Subject: ABNORMAL HEATER PERFORMANCE AT IDLE	Bulletin No: 07-001/06
	Last Issued: 3/13/2006

2006 MX-5 vehicles with VINs lower than JM1 NC**** 60 111258 (produced before December 22, 2005)

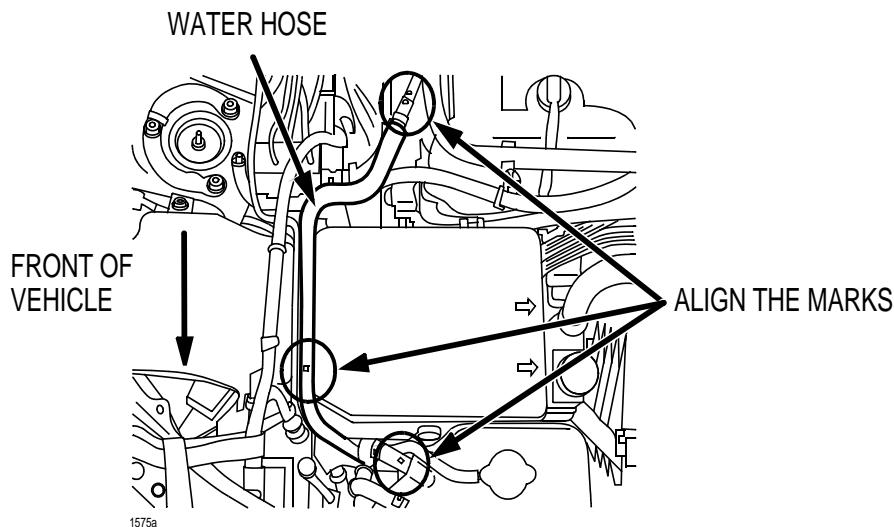
Some customers that park their vehicle on a decline or brake hard during cold engine conditions may experience abnormal heater performance at idle. This condition can be the result of air moving up from the radiator sub-tank through the thermostat housing and becoming trapped in the heater core and/or its supply lines.

To prevent this condition from occurring, the shape of the hose between the radiator sub-tank and the thermostat has been changed. Customers having this concern should have their vehicle repaired using the following repair procedure.

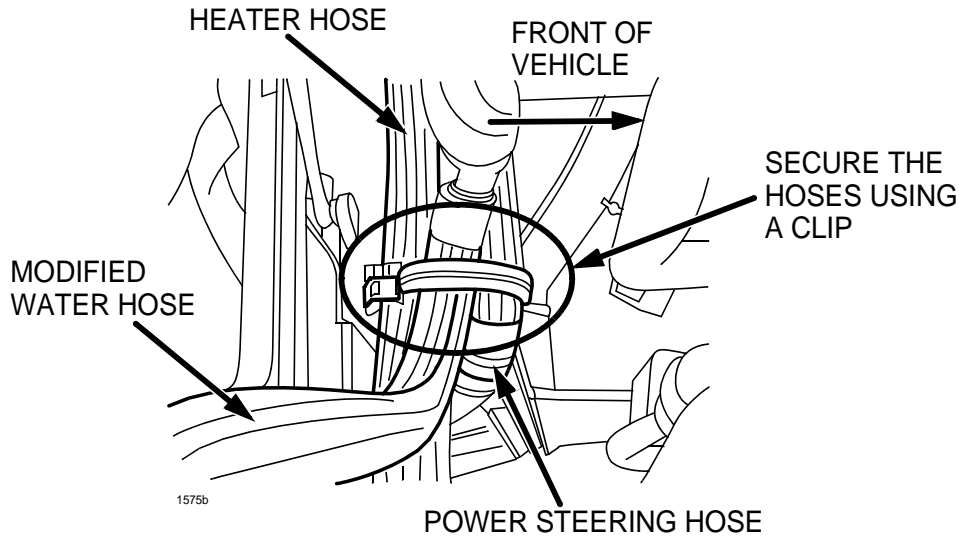
- If the engine is very hot and the water hose is compressed, be careful when removing the cooling system cap. Wrap a thick cloth around it and slowly turn it counterclockwise to the first stop. Step back while the pressure escapes before proceeding with any repair.
1. Verify customer concern.
 2. Remove the water hose.
 3. Align each mark and fit a modified water hose.

4. Using a clip, secure the modified water hose, heater hose and power steering hose together.
